SUBJECT: DRAFT SITE CHARACTERIZATION ANALYSIS ON BWIP SCR  
OPS PLAN NO. 311221E

Attached is a preliminary draft of the Draft SCA for the Basalt Waste Isolation Project as required per OPS Plan Commitment No. 311221E for January 28, 1983.

**SITE CHARACTERIZATION ANALYSIS**

THE U.S. DEPARTMENT OF ENERGY  
SITE CHARACTERIZATION REPORT  
FOR THE  
HIGHTWATER WASTE ISOLATION PROJECT

Figure 1. DOE's Conceptual Model of Groundwater Flow.

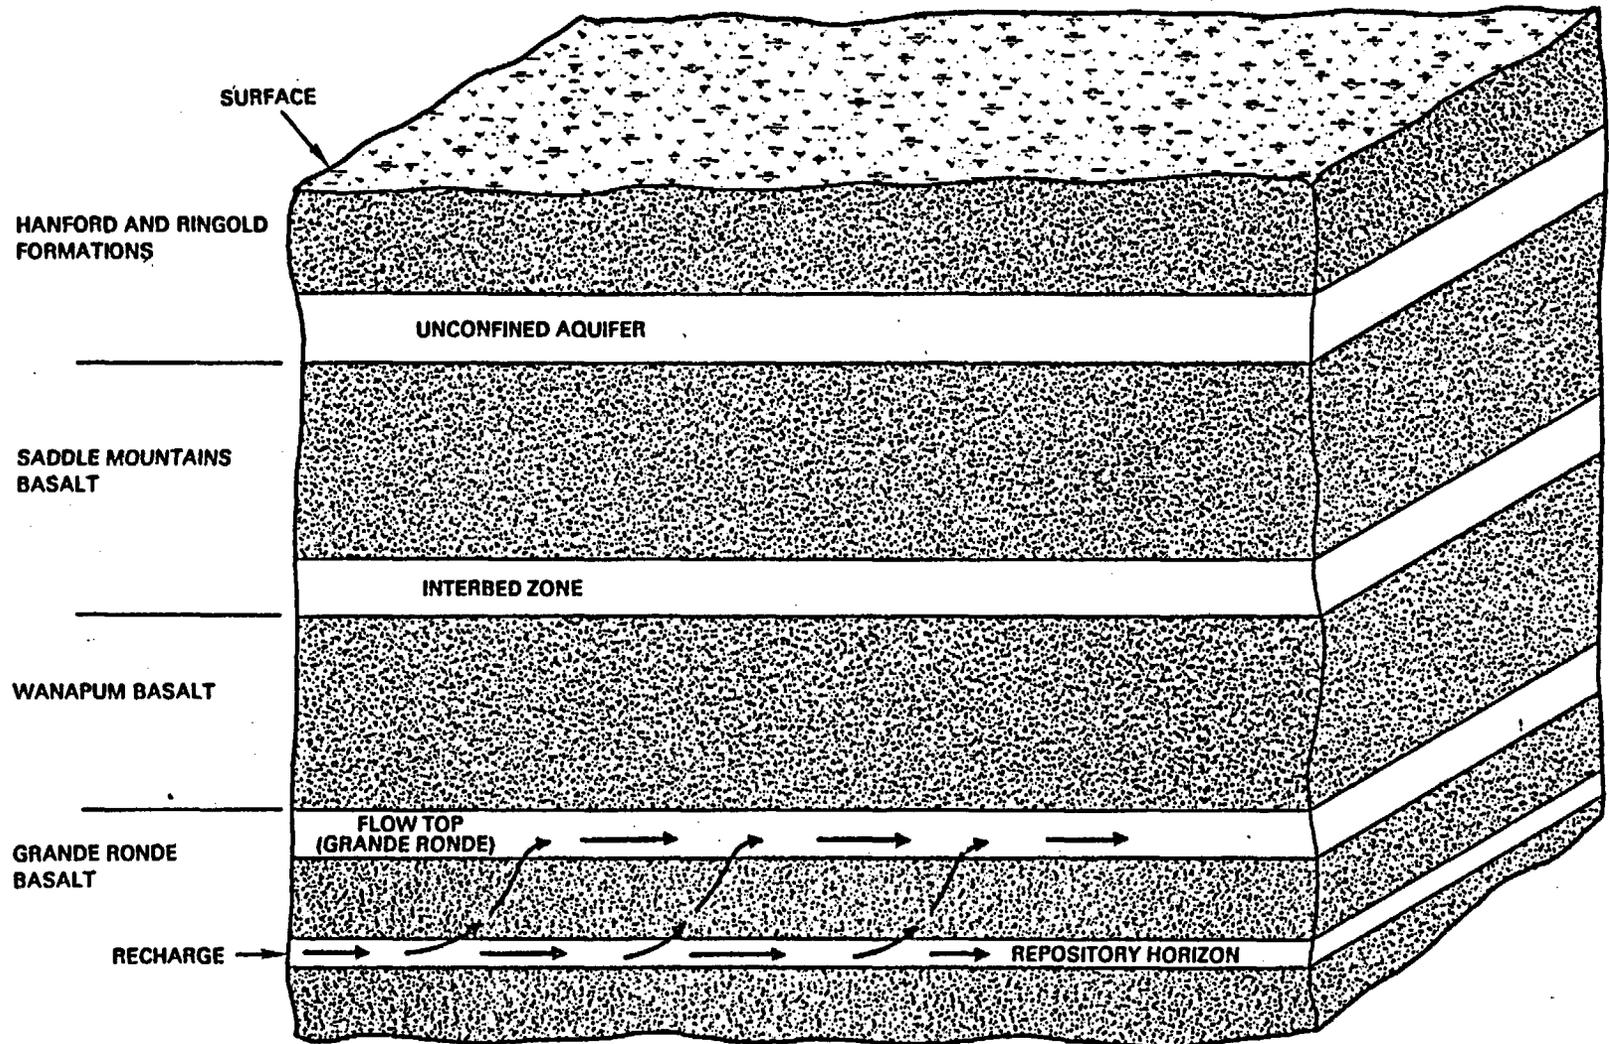
The conceptual groundwater model presented in the SCR is based essentially on a geologic system that consists of areally continuous, layered basalt flows and interbeds of the Columbia River Basalt Group (Figure 1). The main features of this model are that the flow systems are layered and confined, with interbeds and flow tops acting as homogeneous aquifers and low-permeability columnar basalt zones acting as homogeneous confining layers. Horizontal and vertical hydraulic gradients are interpreted to be minimal. While DOE recognizes that vertical leakage potentially occurs across flow interiors, strong assertions are made that little vertical flow occurs between shallow and deep flow systems in undeformed areas. Apparent breaks in key hydrochemical parameters are interpreted by DOE to indicate separation of shallow and deep flow system. While

The areally continuous, layered geometry of basalt flows and interflows, with minimal, homogeneous vertical hydraulic conductivity of each unit and minimal, homogeneous horizontal hydraulic conductivity of flow interiors establishes a very nonconservative base case for travel-time and transport calculations. The conceptual and numerical models presented in the SCR do not account adequately for the effects on groundwater of structural and stratigraphic discontinuities that are known to exist in the Columbia River Basalts (Appendix 2). Figure 2, which is a reproduction of SCR Figure 3-29 (page 3.5-30), illustrates complex,

small-scale structural and stratigraphic discontinuities that are spaced meters to tens of meters apart in the Umtanum Flow at the Emerson Nipple Section. Figure 3, a reproduction of SCR Figure 3-52 (page 3.7-29), shows the areal distribution of aeromagnetic anomalies which are interpreted by the BWIP staff as expressions of significant structural features in the subsurface. Many of these features correlate exactly with the trace of major structural features; other features are uncharacterized to date. Irregularities in the distribution of basalts illustrated in the "Top-of-Basalt Contour Map" (SCR Figure 3-51) may well be related to significant stratigraphic discontinuities. Structural discontinuities in the Pasco Basin exist at a variety of scales, from extensive zones of major structural influence (e.g., faulting and fracturing along the Gable Mountain-Umtanum Ridge anticline), through more discrete zones of offset (e.g., the "Nancy Linear"), to small-scale (mm to 1m) tectonic breccias, radiating fans, and cooling joints, which may be spaced meters to tens of meters apart. Stratigraphic discontinuities apparently range in scale from major pinch-outs of basalt flows and sedimentary interbeds to local thickening and thinning of flow-top breccias. The variety and ubiquity of structural and stratigraphic discontinuities apparent in Figure 2 contradict the simplicity of structure and stratigraphy shown in Figure 1, which represents the DOE's conceptual and numerical models.

- (1) DOE should determine bulk hydraulic parameter values, with emphasis placed on state-of-the-art, large-scale, multiple-well pump tests that are combined with continuous head measurements in various hydrostratigraphic units (see Appendix E). These bulk tests should include determination of vertical hydraulic conductivity of both flow tops and flow interiors. Such tests would facilitate objective verification of any conceptual model, provide bulk values of hydraulic parameters including vertical hydraulic conductivity, improve hydraulic head data, provide information on hydrogeologic boundaries, and permit calibration of the numerical model so that defensible travel-time and transport estimates can be obtained.

Figure 3. Interpretive Bedrock Structure Map. (After SCR FIGURE 3-52, p. 3.7-29)

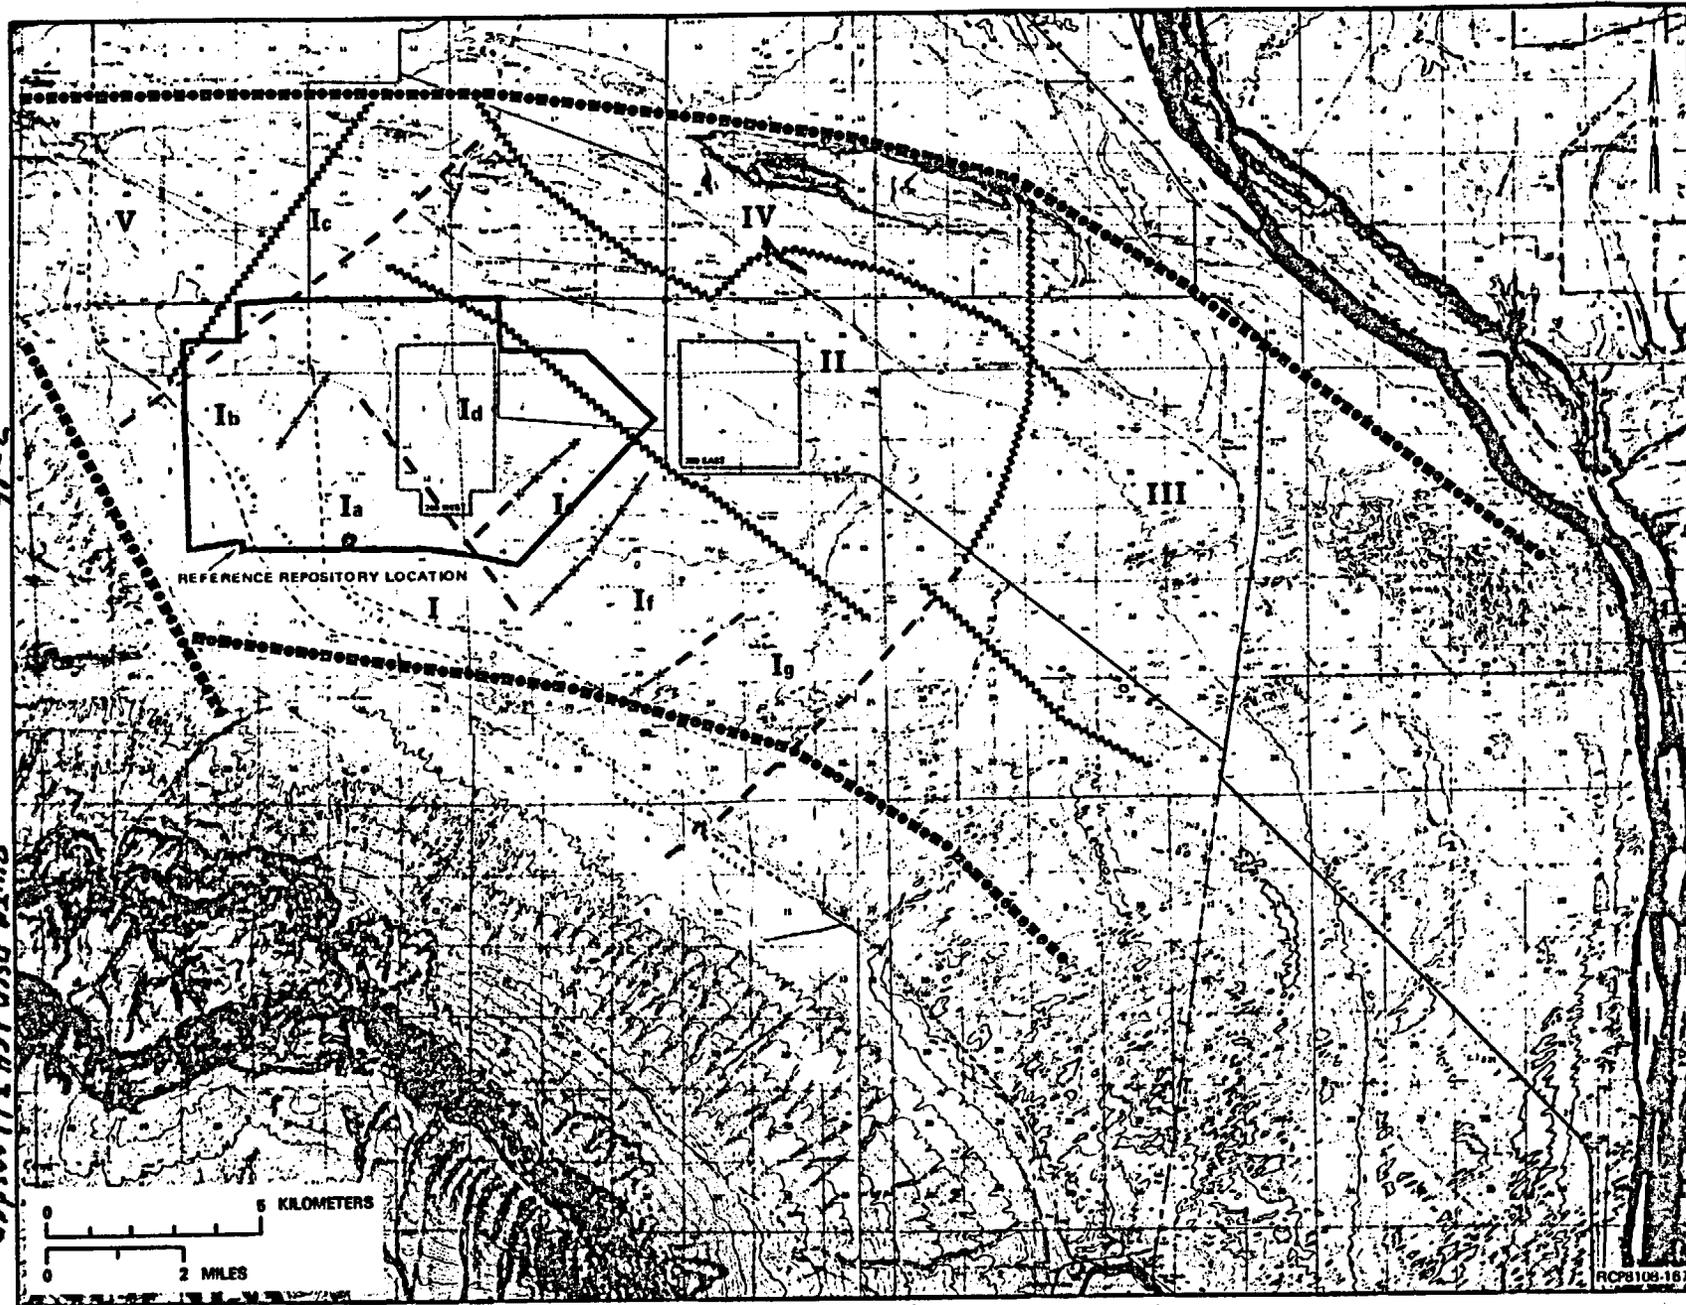
- (3) An areally discontinuous, layered system bounded by high permeability structures. In this conceptual model, the layered basalt system is divided into a series of discrete blocks as suggested by SCR Figure 3-52 (page 3.7-29). The blocks are bounded by vertically disruptive features of high permeability (e.g., fault zones or tectonic breccias) which provide a direct means of recharge and discharge to and from deep aquifers. On the scale of the zone between the RRL and the accessible environment, this is a noncontinuum model for which the porous-flow-equivalent numerical modeling used in the SCR could yield erroneous and nonconservative flow paths, travel times, and radionuclide fluxes.

Figure A-8

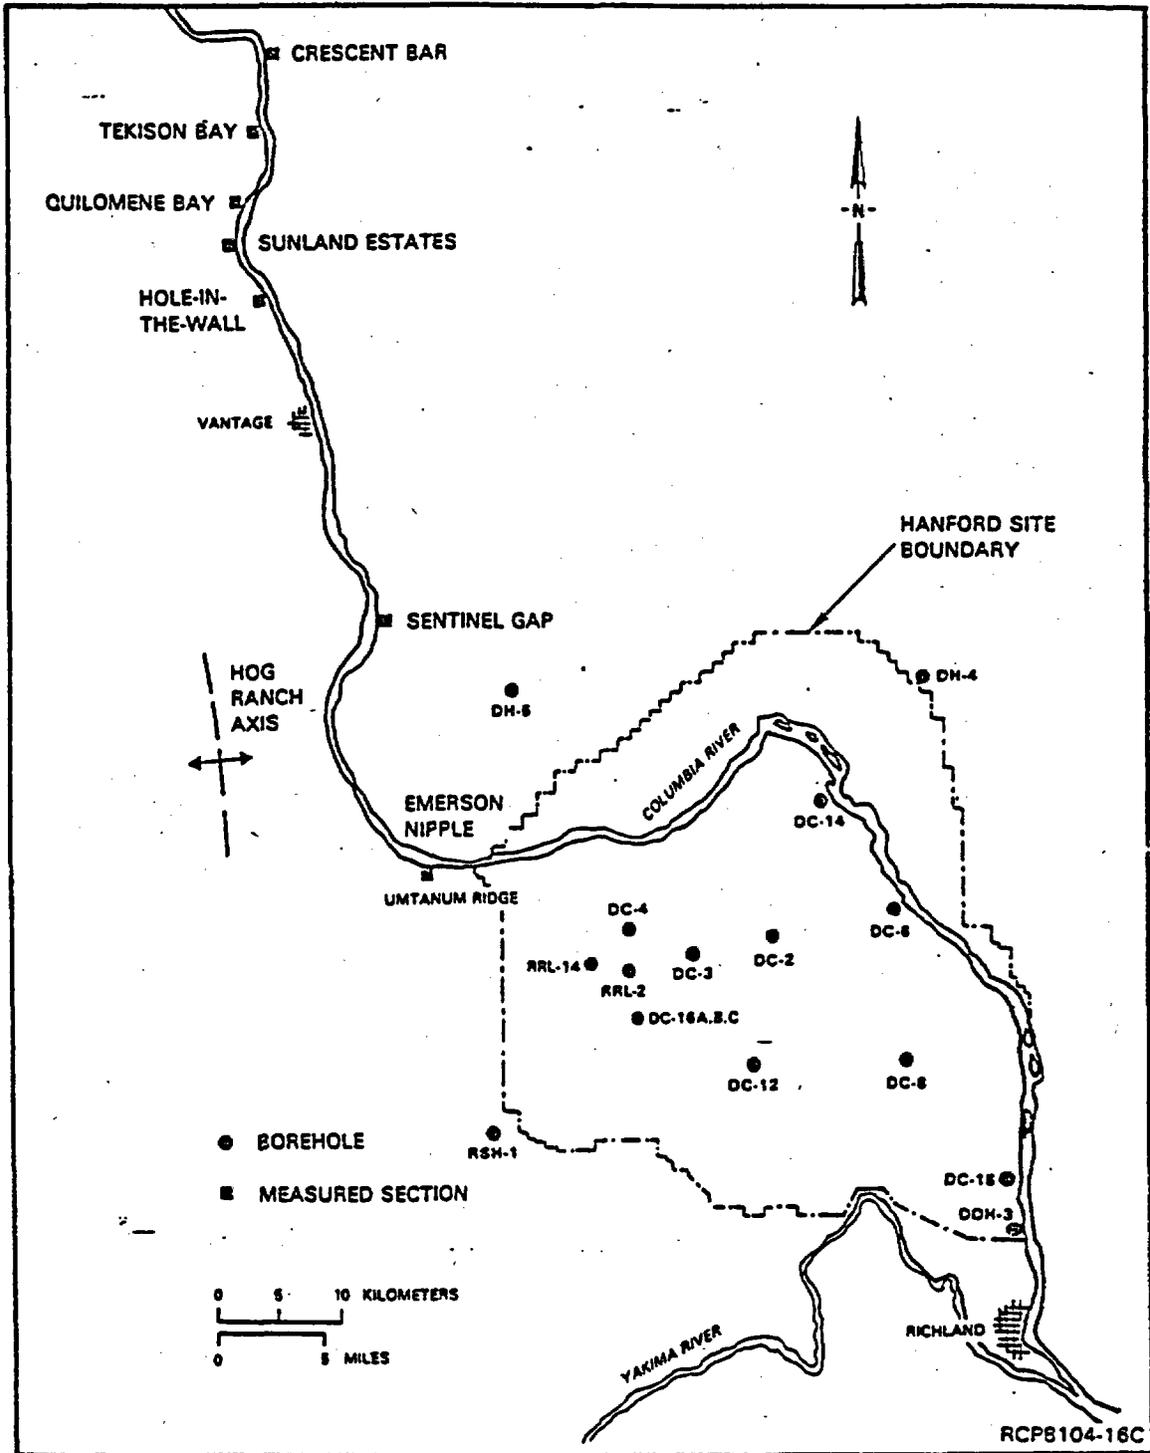
thickness in the Grande Ronde to actual thickness in the Umtanum flow in borehole RRL-2 (Appendix A, Figure A.8).

The apparently anomalous thick flow top and correspondingly thin columnar zones (dense interior) of the Umtanum flow in borehole RRL-2, located 300 feet (91 m) from the proposed exploratory shaft (~~Appendix A, figure~~), exemplifies the uncertainty in predicting intraflow structure.

Figure A-10

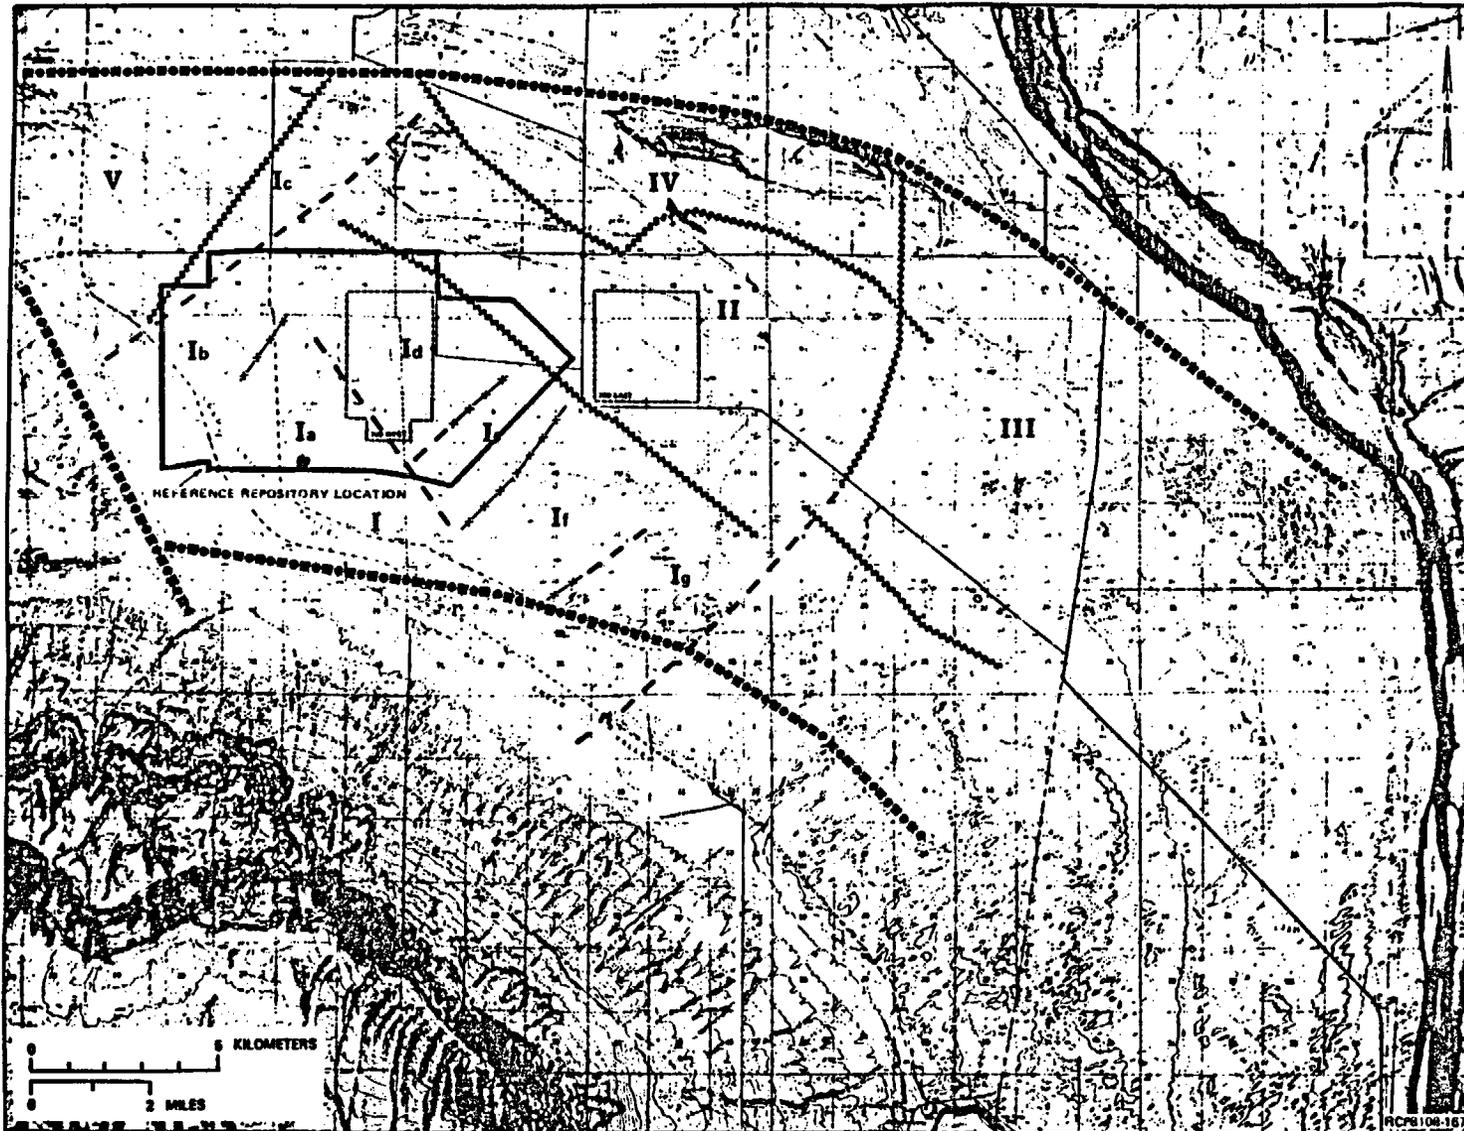
In addition, the DOE should consider that the intact volumes of rock (Appendix A, Figure A.10) discussed by C.W. Meyers in RHO-BWI-ST-14 are far more complex in structure than is indicated in the SCR. These intact volumes of rock are described in the SCR on page 3.7-28, paragraph one. Five lines of reasoning support the NRC's concern:

- o The subsurface geology of the relatively intact volumes of basalt that are bounded by known and inferred structure is too complex to be adequately characterized through planned geologic and geophysical programs.
- o The DOE appears to be placing too much reliance on geophysical surveys to interpret known and inferred structure in the Cold Creek Syncline. Subsurface structure, such as the Nancy Linear, cannot be unequivocally interpreted through the planned geophysical programs.
- o There are no explicit plans to investigate microearthquake triggering mechanisms in the controlled zone. If causative structures are present in the near field of the repository, then the seismic hazard to shafts and horizontal emplacement holes backfilled with a clay-crushed basalt mixture should be considered.
